## Safety Recall: DC-DC Converter Output Cable Is Pinched by IPU Lid

Install a terminal cover kit on the end of the DC-DC converter output cable.

P/N 06060-RMX-000, H/C 8621013

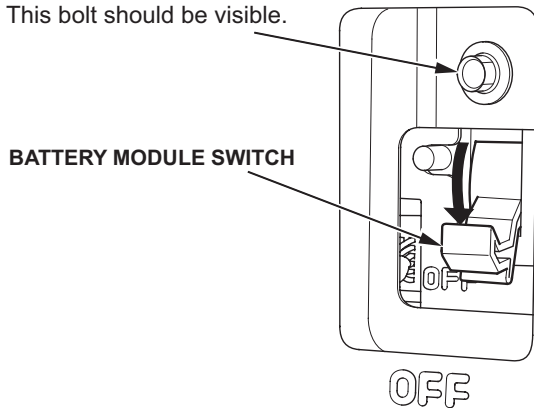
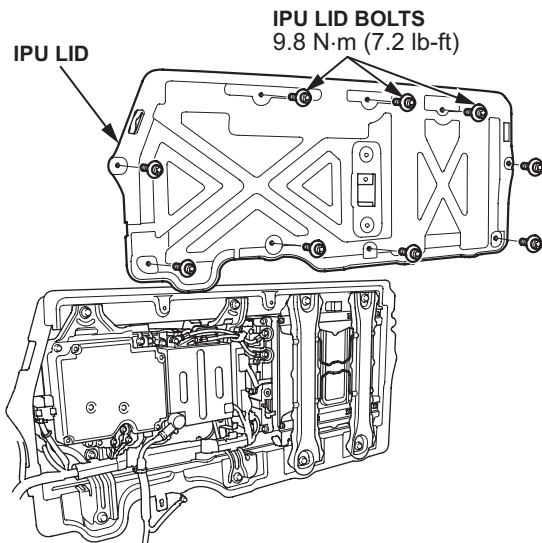
- Turn the battery module switch to OFF. Make sure the bolt above the switch is showing.

This bolt should be visible.

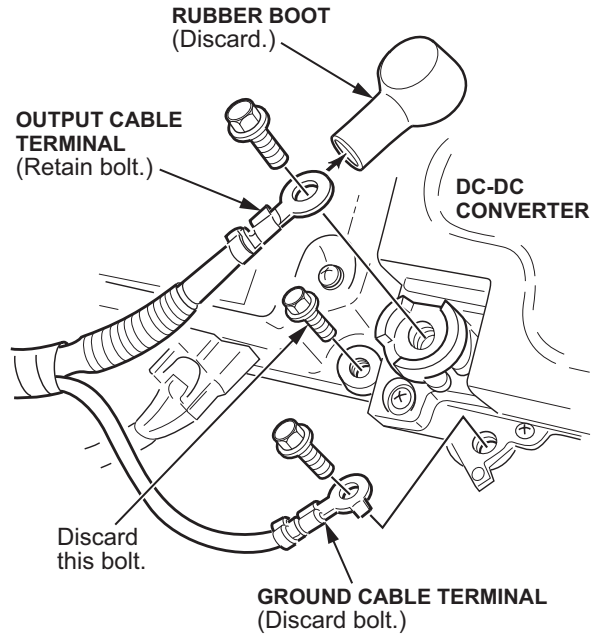
- Wait at least 5 minutes for the IMA system capacitors to discharge.
- Remove the IPU lid bolts and the IPU lid.

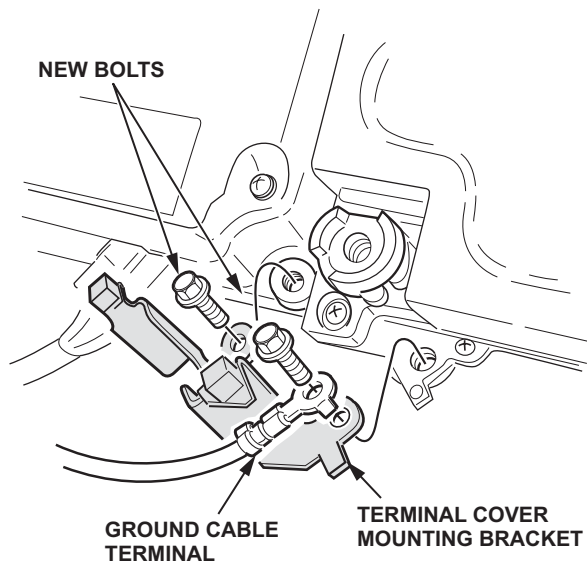
- Check the position of the DC-DC converter output cable terminal. If the terminal sticks up from the DC-DC converter, bend it down slightly with your hand.
- Disconnect the output cable terminal (one bolt). Remove the rubber boot covering the terminal.

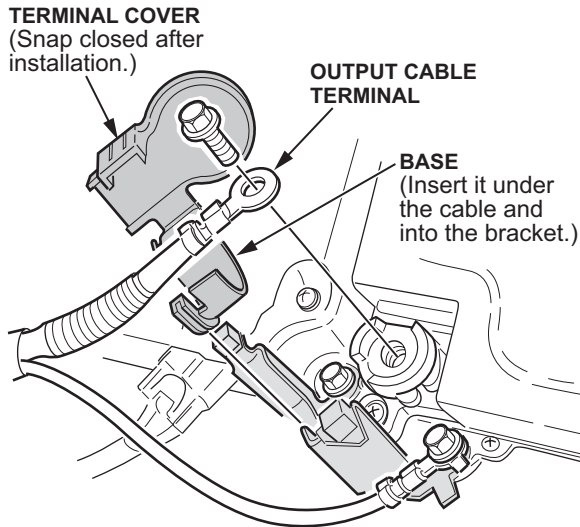
- Disconnect the DC-DC converter ground cable terminal (one bolt). Also, remove the bolt to the left of the output cable terminal. Discard the bolts. These two bolt holes will be used to attach the terminal cover mounting bracket.
- Hold the mounting bracket over the two bolt holes, then attach it and the ground terminal using the two bolts from the terminal cover kit.

12. Insert the base of the terminal cover under the cable and into the mounting bracket. Reconnect the output cable terminal with its original bolt.
